**PRE-BID MEETING MINUTES  
ADDENDUM NO. 1  
ELECTRICAL IMPROVEMENTS AT THE DELAWARE ARMY NATIONAL GUARD  
SCANNELL READINESS CENTER  
DE ARNG CONTRACT NO. 22-2013**

**FE&ES Comm. No.:** 13-1116

Pre-Bid Meeting Minutes & Addendum No. 1

Electrical improvements at the  
Delaware Army National Guard  
Scannell Readiness Center

**2**  
E-2 **ELEC. RM PLAN - NEW WORK**  
SCALE: 1/8"=1'-0"

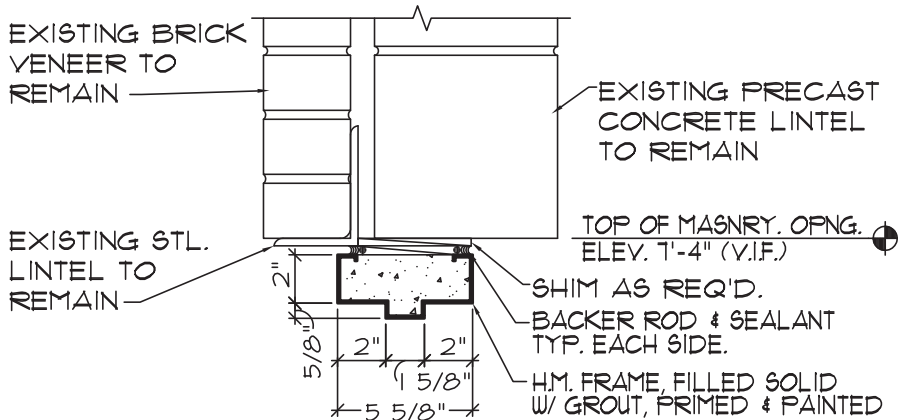
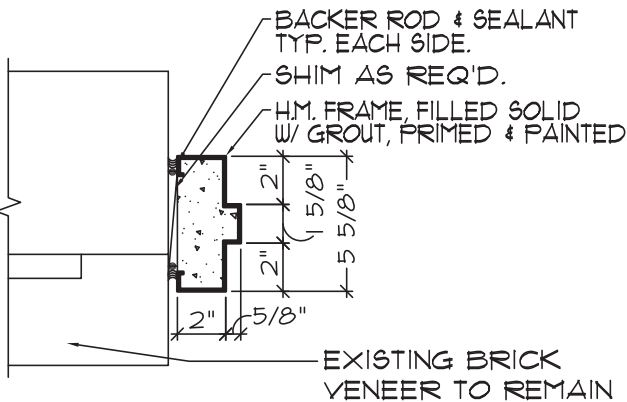
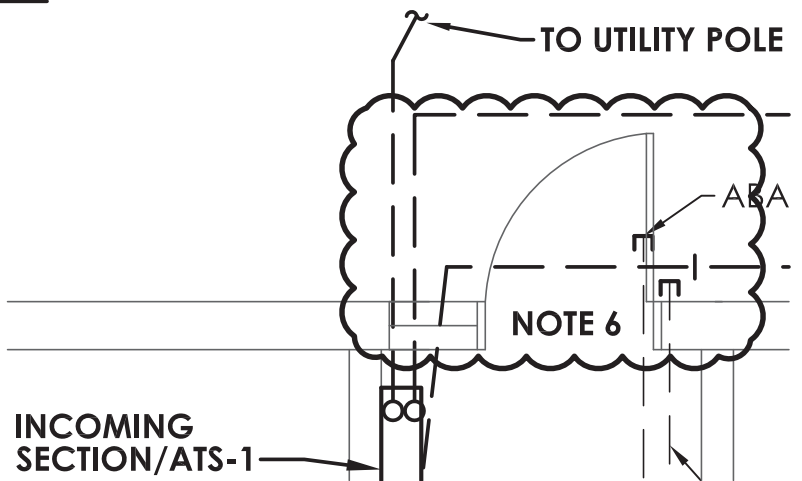
24.2 Revise new door and storefront layout per detail 2/E-2 on Sketch SKA-1.

6  
E-5

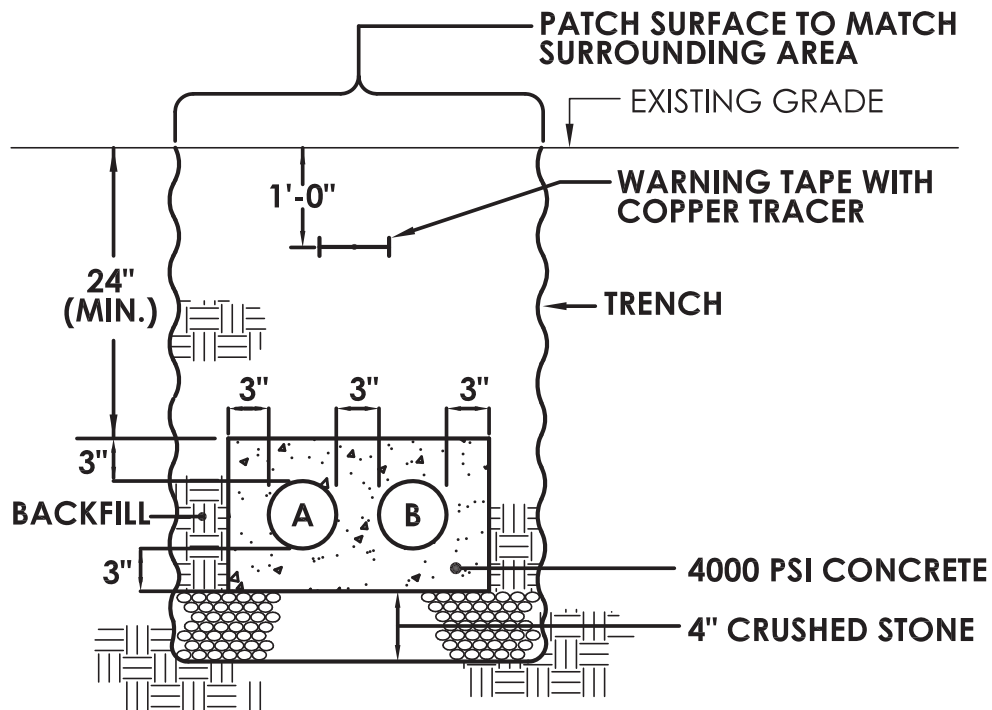
Q4: Dwg E2 note 1 calls for the service conduits to be removed. Are they encased in concrete? Need final location of the generator annunciator.

A4: 2-4” Conduits from Utility Pole to building shall be new per Feeder Type 1 on Single Line Diagram and concrete encased per new detail 6/E-5 on Sketch SKE-1. Location of Annunciator will be determined in the field. For bidding purposes, include up to 100 ft of run inside building.
